<b>Tender Questions and Answers</b>	<b>Document Identifier</b> 240-7124948	<b>Rev</b> 1
		<b>Effective Date</b> 01 April 2023	
		<b>Review Date</b> April 2026

<b>Request for Enquiry Number</b>	<b>WCKBG2516SB</b>
<b>Description / Project Title</b>	<b>THE SUPPLY AND REPLACEMENT OF THE INVERTERS AND AUXILIARY SYSTEM AT KOEBERG OPERATING UNIT (KOU)</b>
<b>NEW Tender Questions Closing Date</b>	<b>16 May 2024</b>

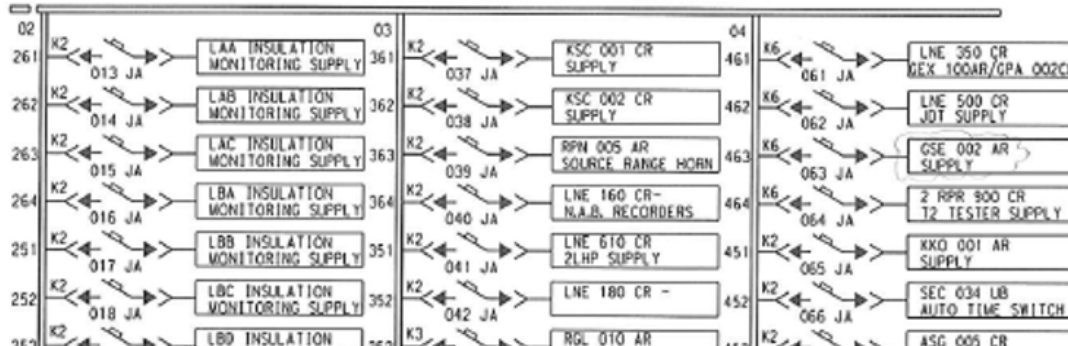
No.	Document	Section	Page	Requirement	Questions	Answers
29.					In the document provided by Eskom, Rev4_Q27_Item 7_Single Line Diagram, there is the single line drawing but the breakers capacity is not referenced, see below. Can you specify the output breakers capacities?	Breaker capacities are K1, K2.. ect. See KBA1217LOO052 (PDF page 49) supplied previously also found attached "Rev 5_Q29_Item 1_Feeders – info"
30.					We do not find, in the attached documents, the single line diagrams of 0LZC 001 and 6SSC/D, could you please send them?	0LZC single line diagram can be found on page 64 of "Rev 3_Q18_Item 2_OLZC - info.pdf" breaker size for 0LZC can be determined from the text of the same document.  6SSC/D docs can be collected from Koeberg. See 26
31.					Cable entry for each switchboard is also necessary: LNE 001/2/3, 9LNF/G/H , 0LZC 001 , 6SSC/D	See TRS table 4
